**AMENDMENTS TO THE DRAWINGS**

In response to the Office action identified above, Fig. 2-5 has been revised. One clean copy of Fig. 2-5 has been provided along with one marked copy showing the changes made.

Fig. 2

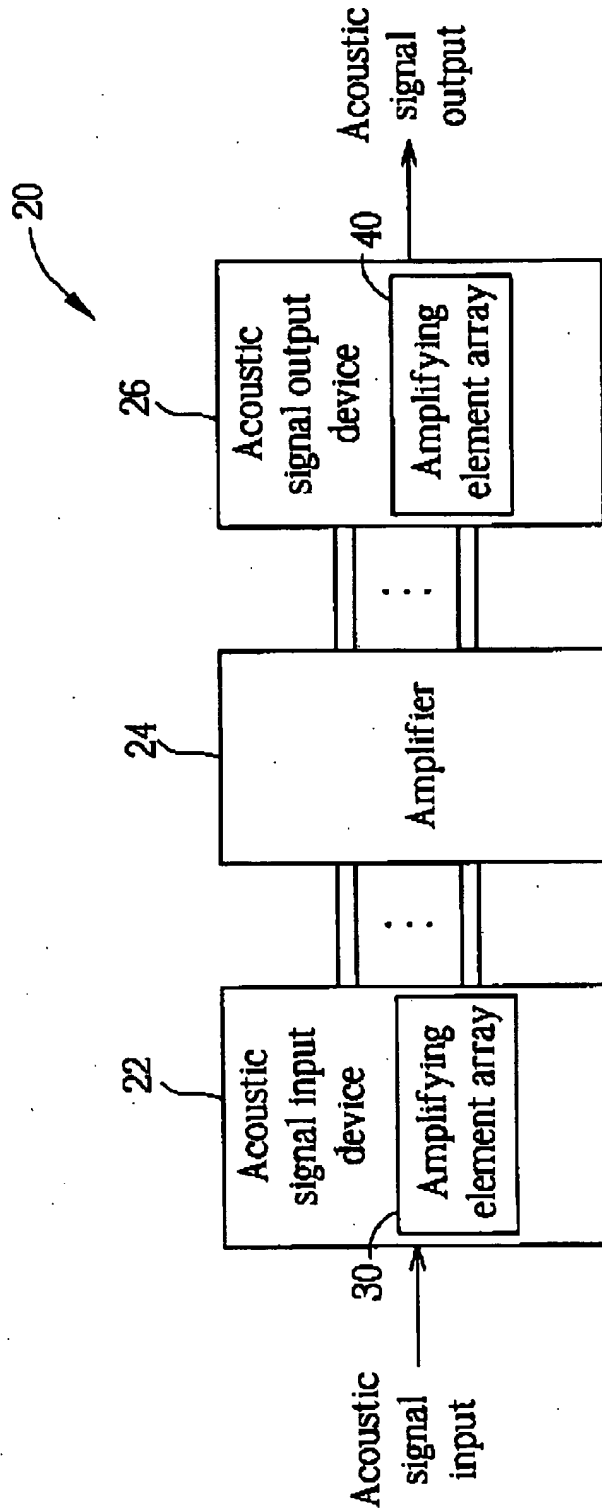
In Fig. 2, the acoustic signal input device (22) comprises an amplifying element array (30), and the acoustic signal output device (26) comprises another amplifying element array (40). The hearing aid device receives an acoustic signal input and outputs an acoustic signal output.

Fig. 3

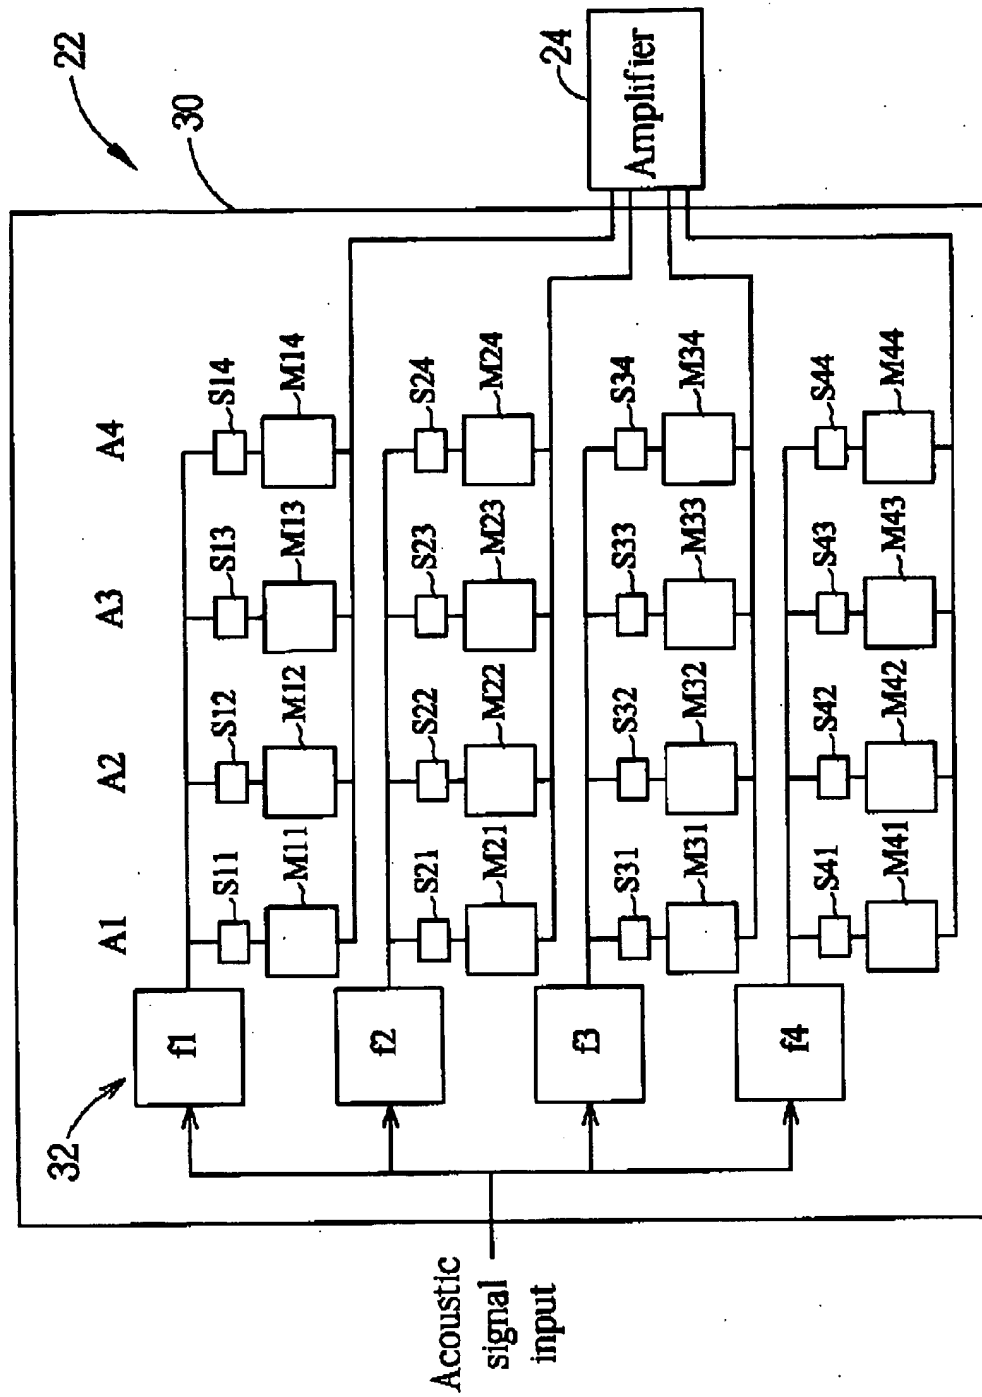
In Fig. 3, the acoustic signal input device (22) receives an acoustic signal input and comprises an amplifying element array (30).

Fig. 4

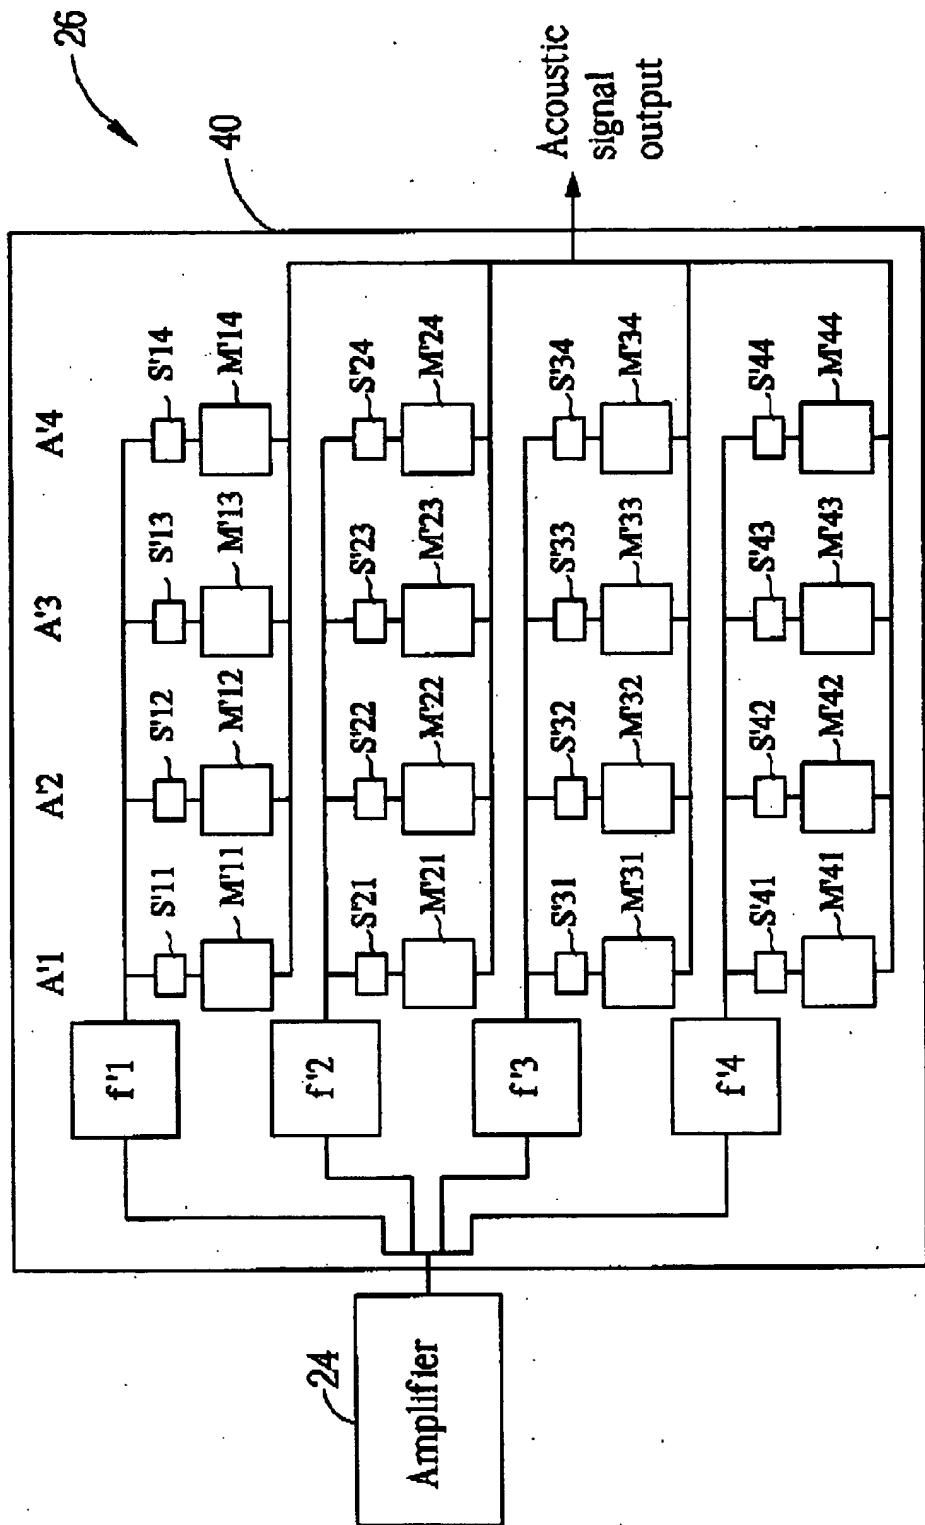
In Fig. 4, the acoustic signal output device (26) comprises an amplifying element array (40) and outputs an acoustic signal output.

Fig. 5

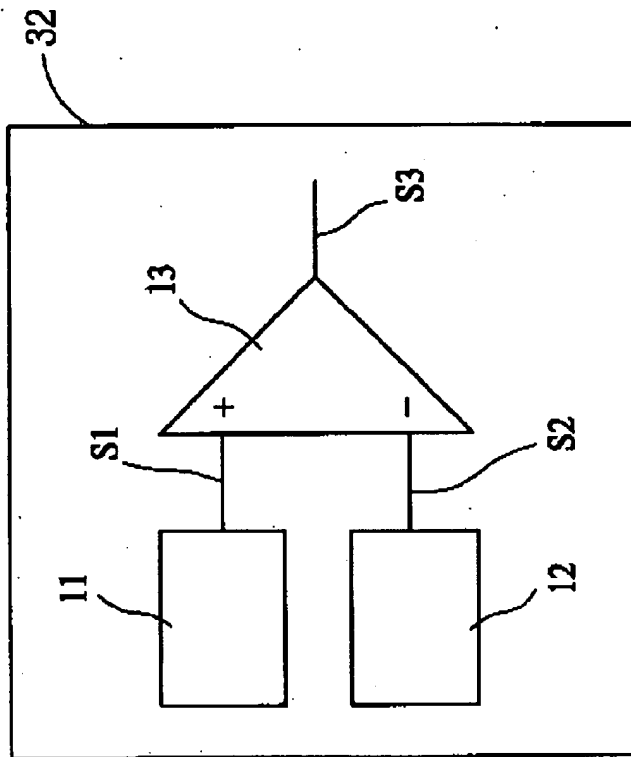
In Fig. 5, the bandpass filter (32) comprises two acoustic receiving units (11), (12) with different resonant frequencies and a differential amplifier (13).
